Technical Service Bulletin

Subject: WRONG VEHICLE LOCATION IN GPS WITH DTCS B119F:01, B119F:13 AND/OR B119F:2B STORED	Bulletin No.: 09-021/20
	Last Issued: 12/10/2020

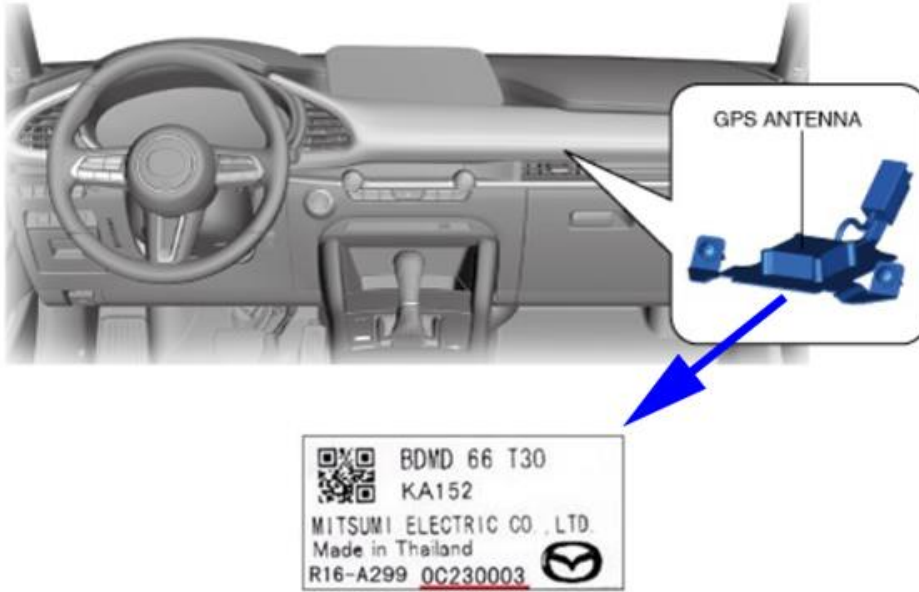
This concern may be caused by incoming noise disturbing the reception of GPS signals, resulting in the wrong vehicle location and the DTC stored. To eliminate this concern, the GPS antenna has been modified.

1. Verify customer concern.
2. Confirm if the telephone antenna No.1's lot number is before 0C230003. The lot number is in YMDDnnnn format.

NOTE: The part number has not been changed for this modification.

- If the lot number is 0C230003 or later, the part is already modified.
- If the lot number is before 0C230003, replace the GPS antenna with a modified one by referring to the instructions on MGSS.
 - Mazda3: (GLOBAL POSITIONING SYSTEM (GPS) ANTENNA REMOVAL/INSTALLATION)
 - CX-30: (GLOBAL POSITIONING SYSTEM (GPS) ANTENNA REMOVAL/INSTALLATION)
